Access Compliance Report

Public Rights-of-Way

(Curb Ramps)

Intersection ID: 6326	Main Street: UNIVERSITY_CITY_BV	Cross Street: CHANCELLOR_PARK_DR	Location:	SE
ADA ID: 3CDF928D7447	Ramp Type: BlendTrans1	Initial Pass/Fail: Fail	Overall Compliance: No	Severity Score: 10

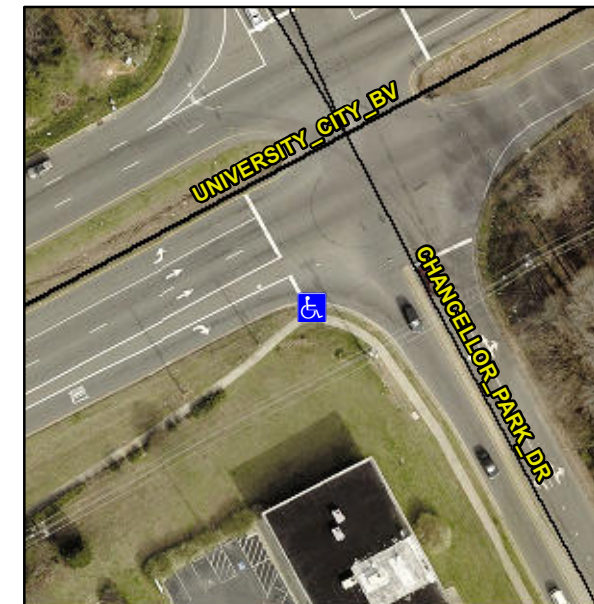
Not Found, R304.5.1, R304.5.3

Remove & Replace Curb Ramp With Two New Directional Ramps or Equivalent.
